MILITARY SPECIFICATION

LOUDSPEAKERS, PERMANENT MAGNET, BLASTPROOF
AND SUBMERSIBLE, NAVY TYPE 4954b ()

This amendment forms a part of Military Specification MIL-L-16225B(SHIPS), dated 12 January 1961.

FIGURE 2. Orientation in acoustical tests.

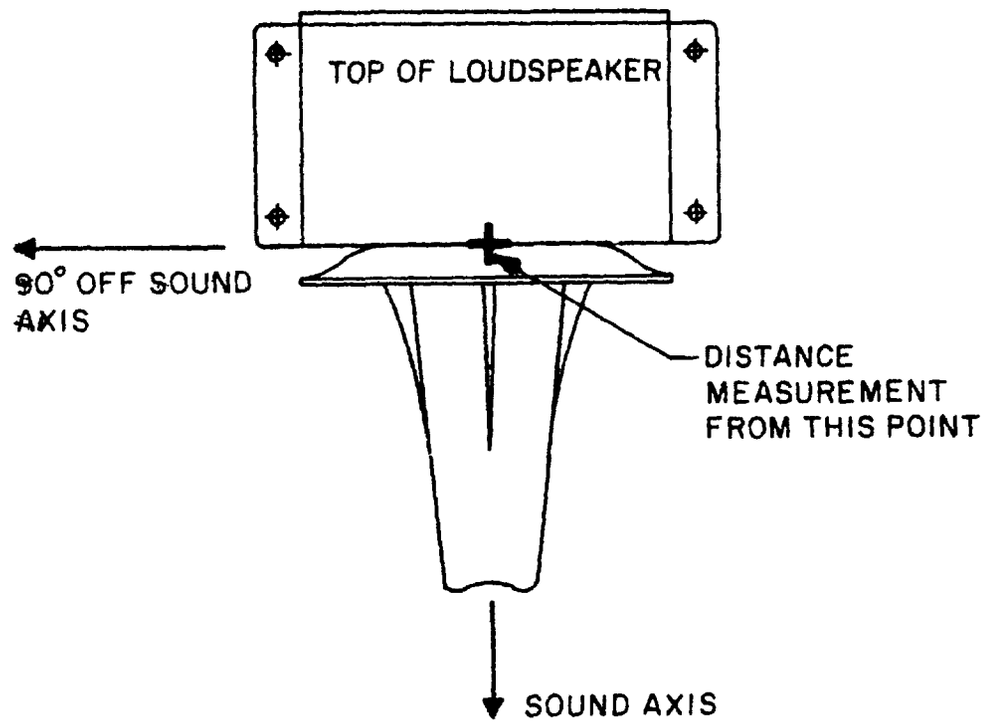
3.6.1, last sentence, delete and substitute: "The frequency response, when tested 90° off the sound axis (see figure 2) shall be within the limits shown in figure 1."

Following figure 1, add figure 2 as printed on page 2 of this amendment.
